# Access Compliance Report

## Public Rights-of-Way

Intersection ID: 47907	Main Street: E_MALLARD_CREEK_CHURCH_RD	Cross Street: JOHN_KIRK_DR	Location:	N
ADA ID: 4A121BCE6A22	Ramp Type: Perp	Initial Pass/Fail: Fail	Overall Compliance: No	Severity Score: 35

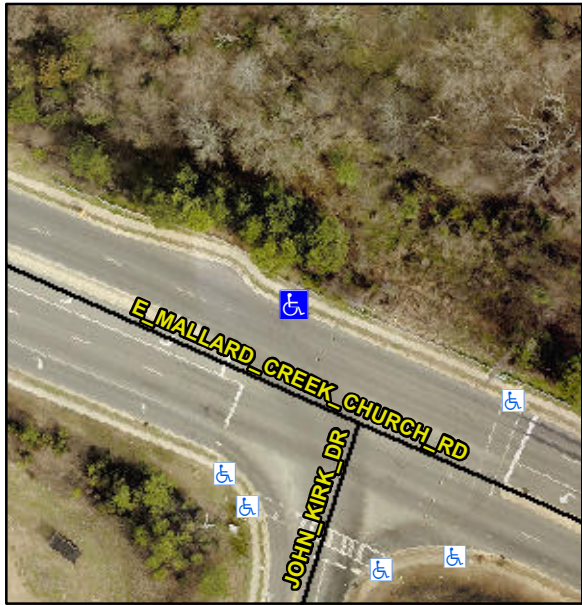
Codes/Mitigation Info/Possible Solution			Field Measurements/Component Compliance					
	Possible Solutions:		Compliance	Description	Data	Compliance	Description	Data
	Remove & Replace Entire Ramp.		N/A	Ramp Length (in)	73.0	No	Ramp Slope (%)	20.0
			No	Ramp Width (in)	47.0	Yes	Ramp XSlope (%)	3.9
			N/A	Flare Type LT	N/A	N/A	Flare Type RT	N/A
			N/A	Flare Slope LT (%)	N/A	N/A	Flare Slope RT (%)	N/A
			N/A	Flare Traversable LT?	N/A	N/A	Flare Traversable RT?	N/A
			N/A	Landing Length (in)	N/A	N/A	DWS Provided?	N/A
			N/A	Landing Width (in)	N/A	N/A	DWS Contrast?	N/A
			N/A	Landing Slope (%)	N/A	N/A	DWS Length (in)	N/A
			N/A	Landing X Slope (%)	N/A	N/A	DWS Full Width?	N/A
Surveyor Notes:		N/A	N/A	Landing Curb? (Y/N)	N/A	N/A	DWS Offset (in)	N/A
PROW/ADA:		R304.5.1, R304.2.2	N/A	Shared Landing?	N/A			
			N/A	Gutter Ponding?	N/A	N/A	Gutter Slope (%)	N/A
			N/A	Gutter Lip Ht (in)	N/A	N/A	Gutter X Slope (%)	N/A
